REPORT TO COUNCIL

Application: DP16-0017, DVP16-0019

Address: 1350 St. Paul St

Subject: Development Permit and Development Variance Permit

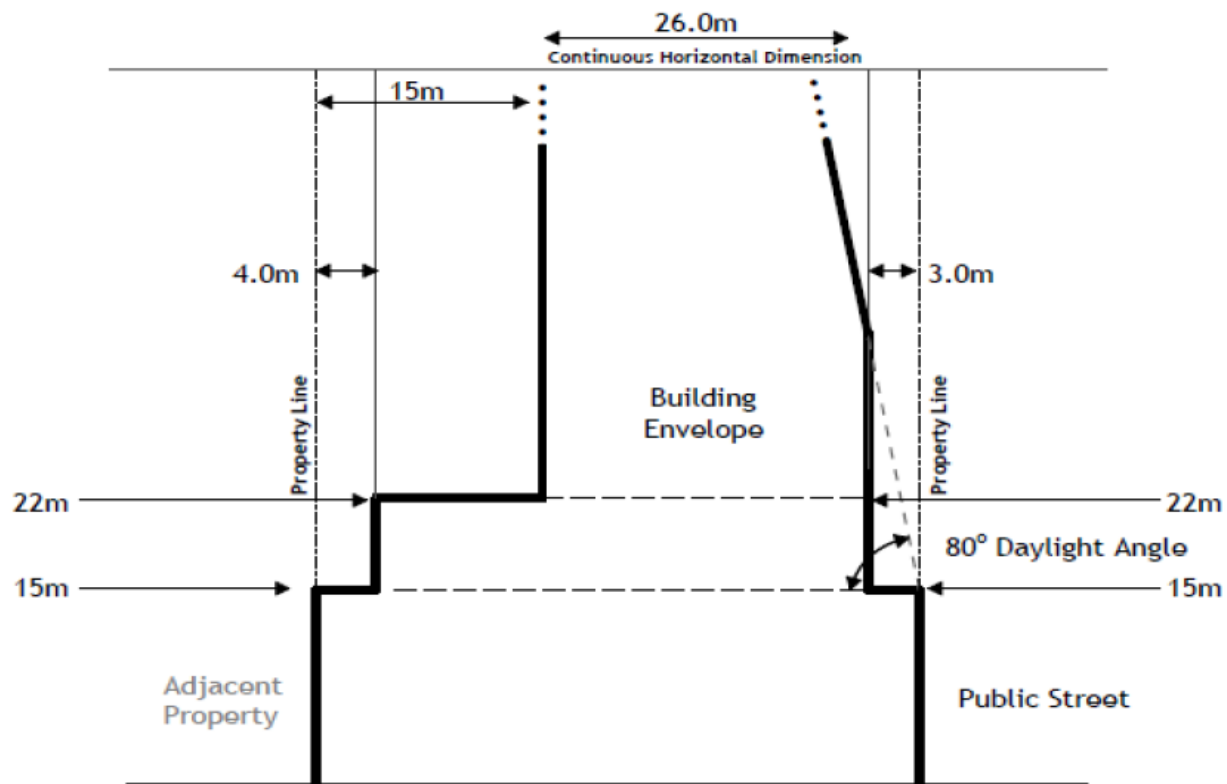
Variances 3, 4, and 5 - Variance to the building setbacks above 15.0m, and to the maximum building angle of incidence.

The applicant has applied to construct a mid-rise 6 storey building. The C7 zone is primarily designed to accommodate low commercial buildings along commercial streets such as Bernard Avenue, or for tall point towers. Despite allowing six storey buildings, C7 zoning provisions make the proposed building difficult to achieve.

Staff have no objections to the proposed variances. The 6 storey building form is appropriate to St. Paul Street, which is developing into a mixed use transitional street. The building form will be similar to those of the original Sole building, the Interior Health Authority building and the Innovation Center.

Illustrative Building Section

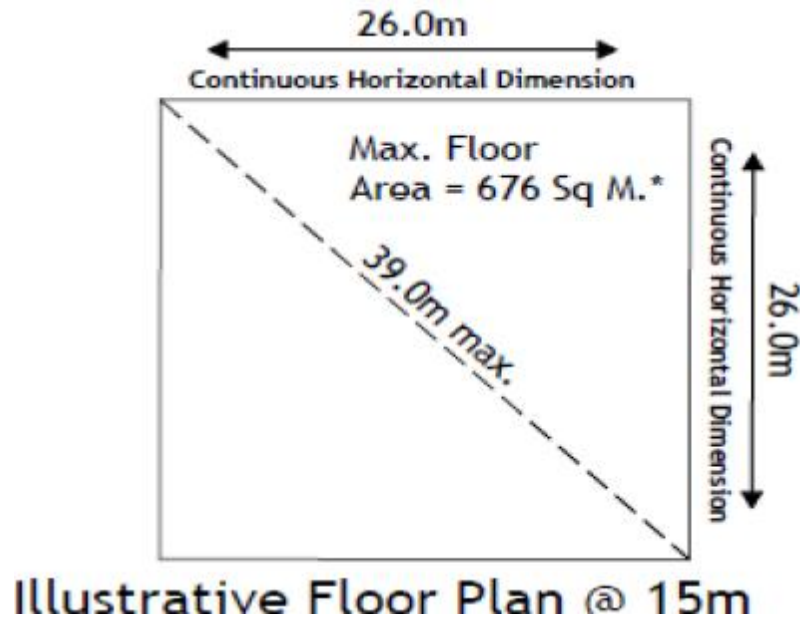
Variances 6 and 7 - Variances to the maximum area and diagonal measurement of floorplate above 15.0 m.

Similar to the above mentioned variances, the restrictions on diagonal measurements and floorplate areas are intended to restrict the impact of tall point towers, above 13 storeys, by limiting their skyline effect. The restrictions render shorter building forms uneconomical.
